NIFTY COPPER PTY LTD

STRIP AND QUOTE HLX5 ROCKDRILL -

Sandvik Mining and Construction Pty Ltd Australia

| Customer: | NIFTY COPPER PTY LTD | Date: | Job number: | 7395639 |

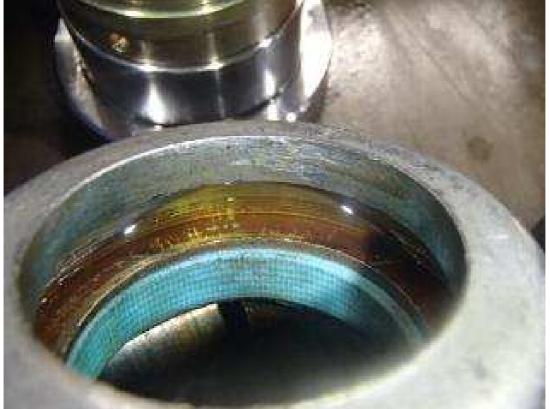
The seal carrier flange bore is worn from general wear

The flushing head requires repairs (build and machine) to the worn seal carrier land to extend its service life. The mounting bolt lands are worn unevenly and need skimming to help prevent the bolts from coming loose.
